PLAN-024757

Proposal: Loft conversion.

Site: 9 Allenye Way, Elmer, Middleton, PO22 6JZ.

M/104/18/HH

Due to surface water inundation issues in the Lidsey Catchment “The applicant is advised to adopt, where appropriate, the measures in the table “Practical measures to reduce the potential impacts of development”.

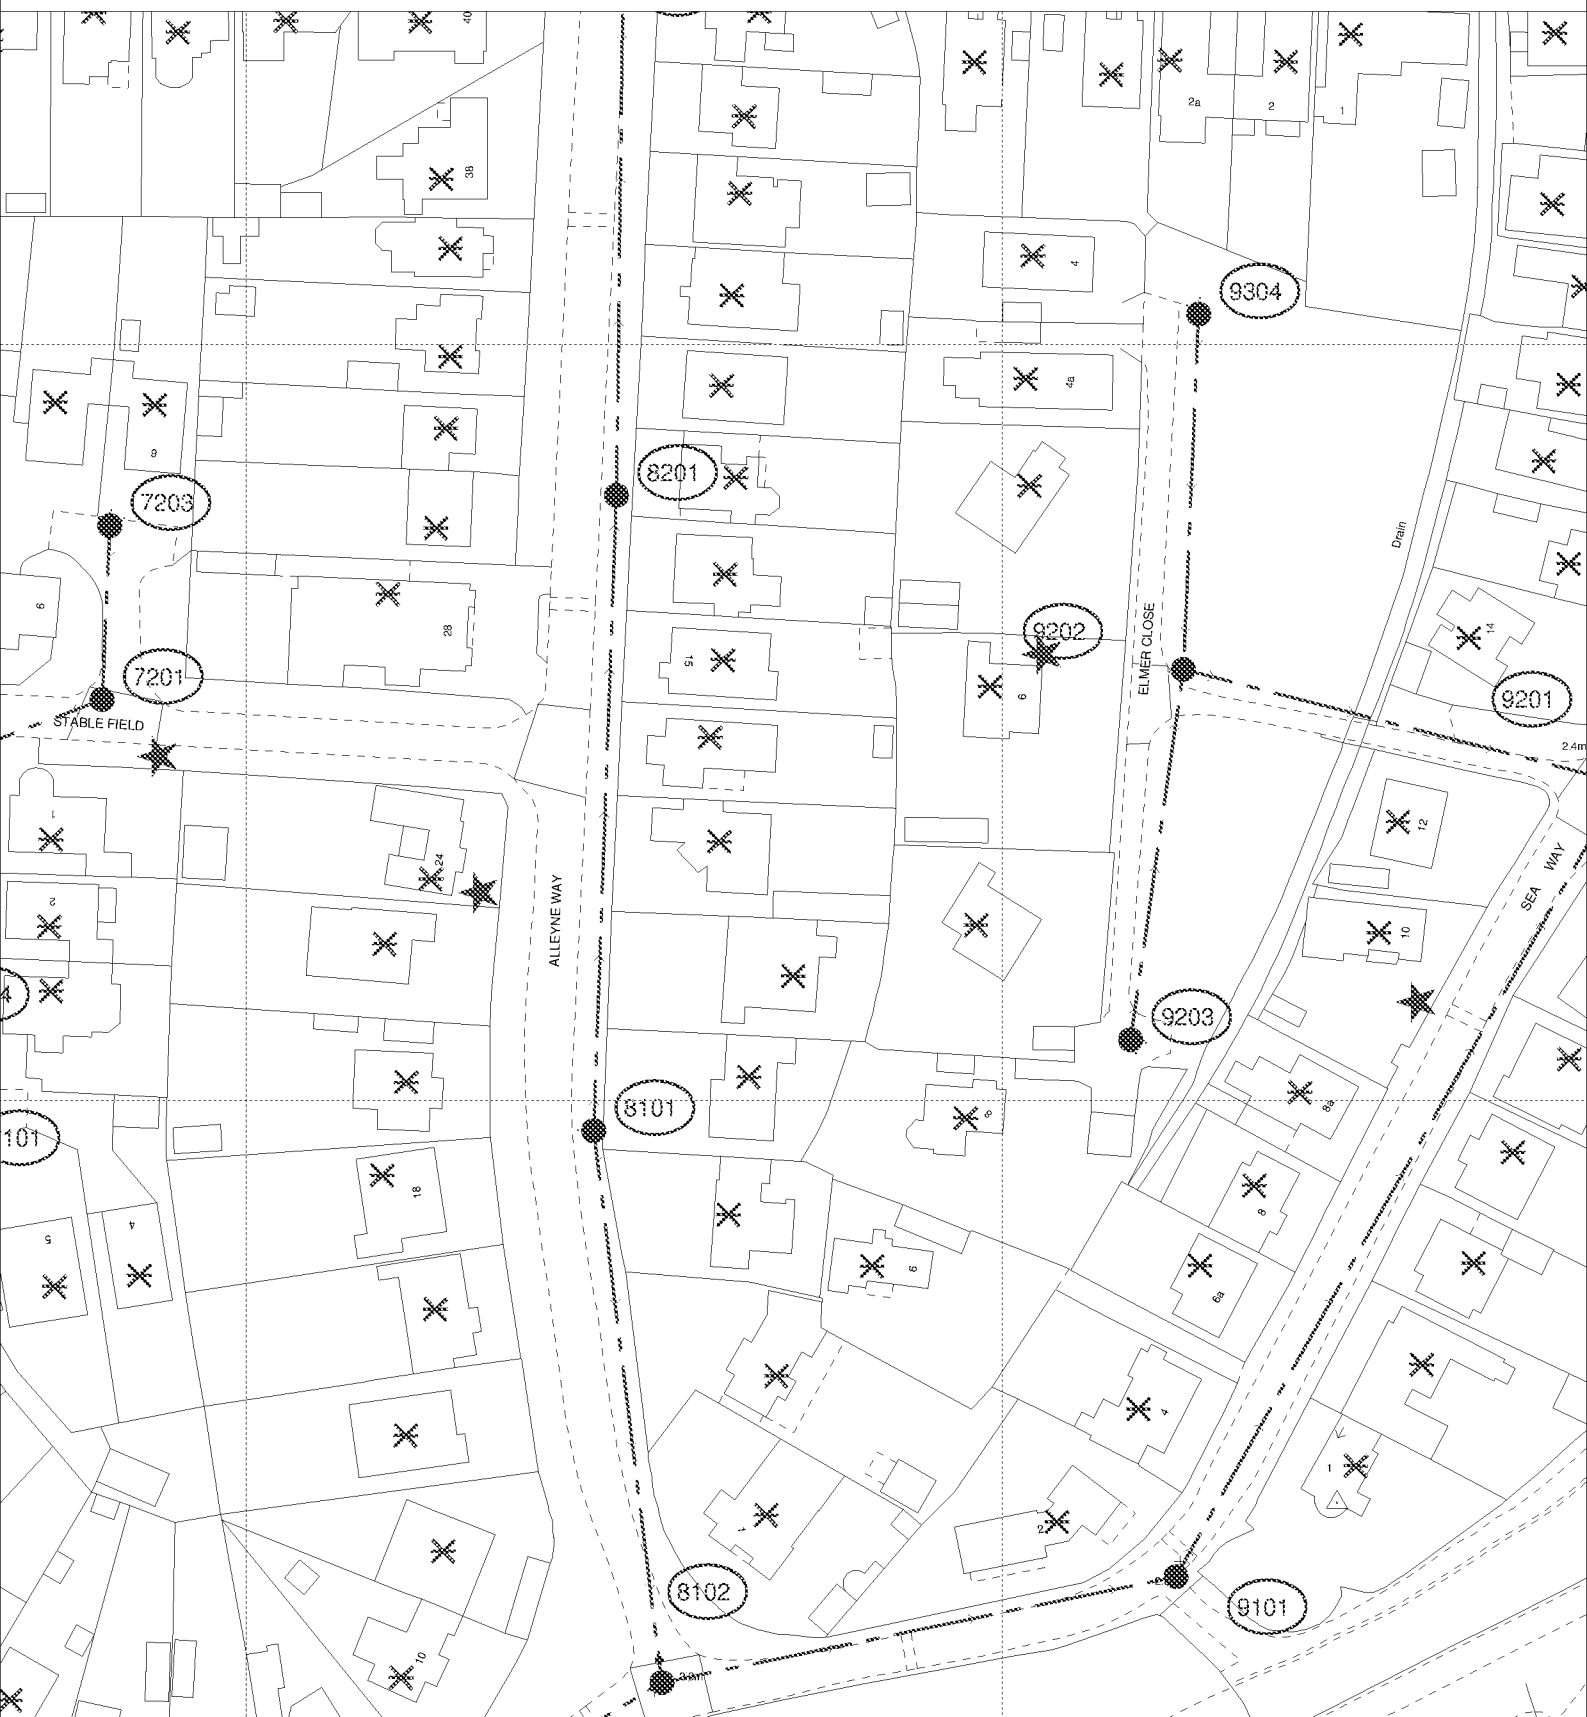
Developer should look to protect the public sewerage system from inundation and infiltration, which contribute to flooding in unfavourable conditions.
